Beatty Line North, Fergus Transportation Impact Study Peer Review Comment Response

17 December 2018
Project: 180135

**RE: BEATTY LINE NORTH, FERGUS TRANSPORTATION IMPACT STUDY – PEER
REVIEW COMMENT RESPONSE**

In July 2018, Paradigm Transportation Solutions Limited (Paradigm) prepared a Transportation Impact Study (TIS)¹. Since submission of the study, County of Wellington consultant Triton Engineering (Triton) peer reviewed the report. The following summarizes our responses/clarification to the 22 October 2018 Triton memorandum². The Triton comments are included for clarity.

DATE: DECEMBER 2018
DWG SD 1

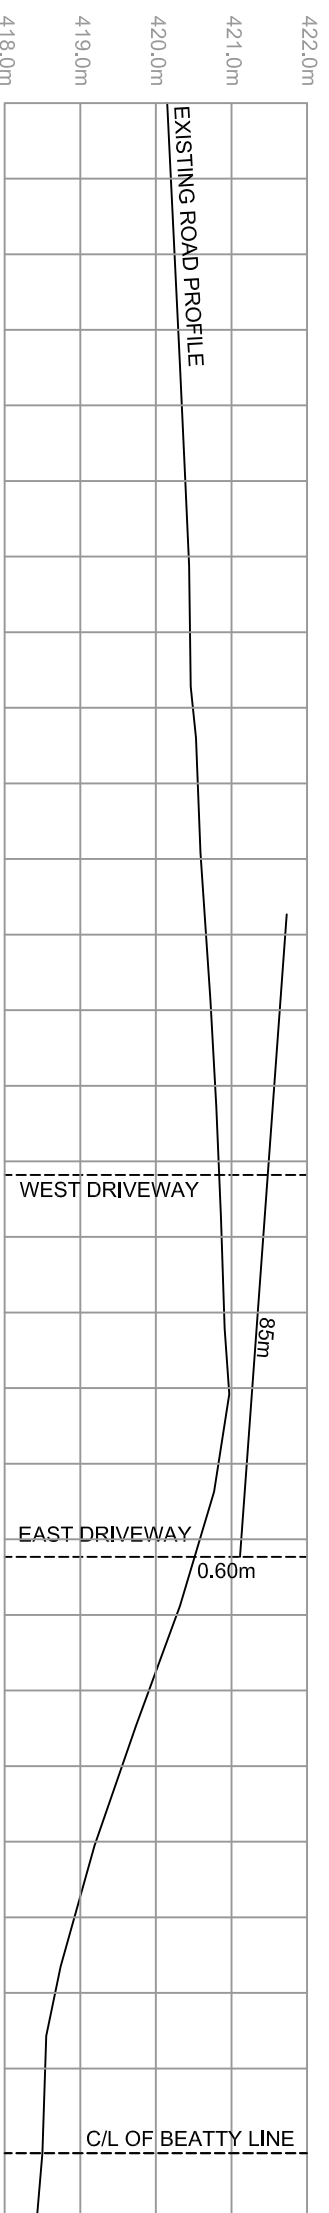
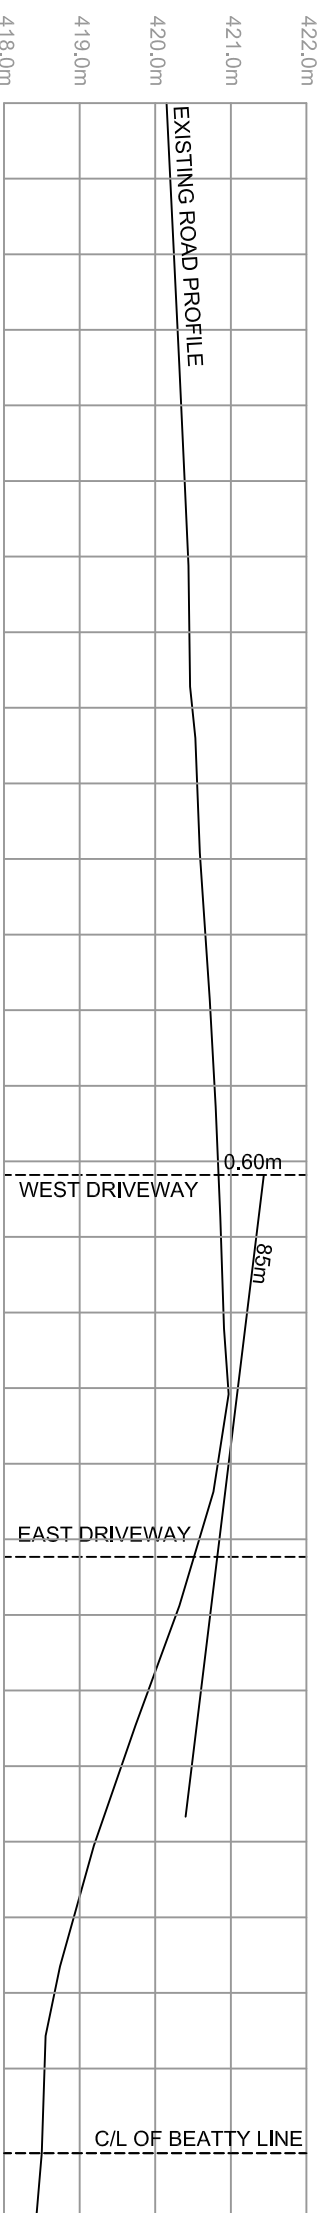
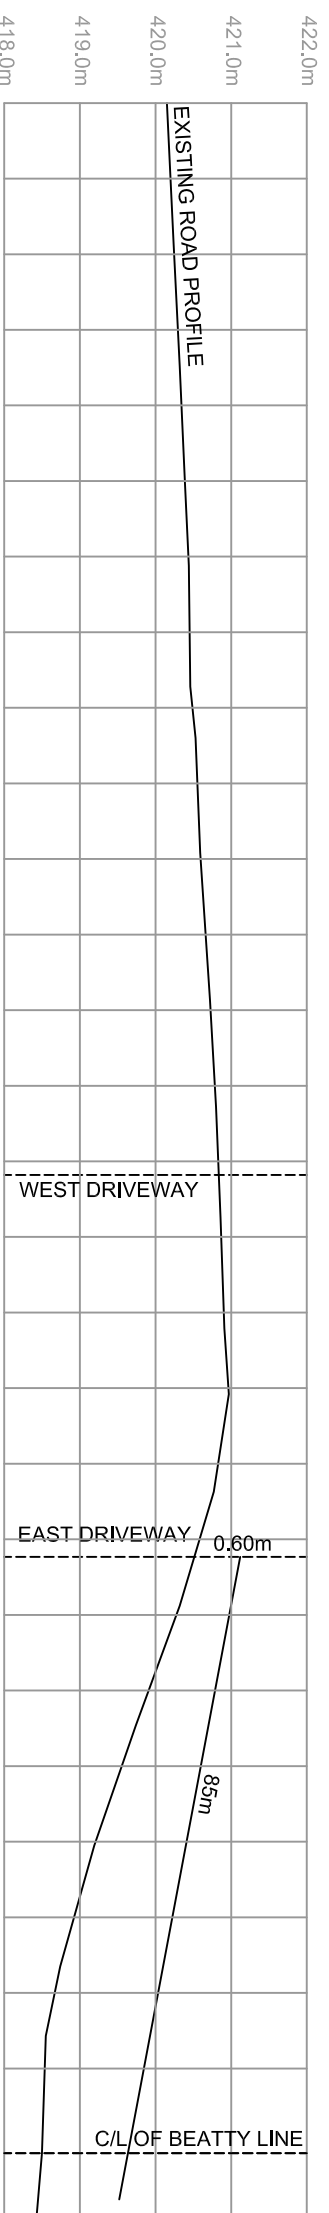
Comment 1.1: Sight Distance – The proposed easterly entrance to the apartment building appears to be located near a crest vertical curve on Farley Road. Provide a profile to demonstrate sight distances at the proposed entrance location

Drawings SD1 and SD2 (Attachment A) illustrate the sight distance profiles for the two (2) proposed Farley Road driveway connections. The drawings indicate that both driveways satisfy the Transportation Association of Canada³ (TAC) sight distance requirements for a 60 km/h design speed.
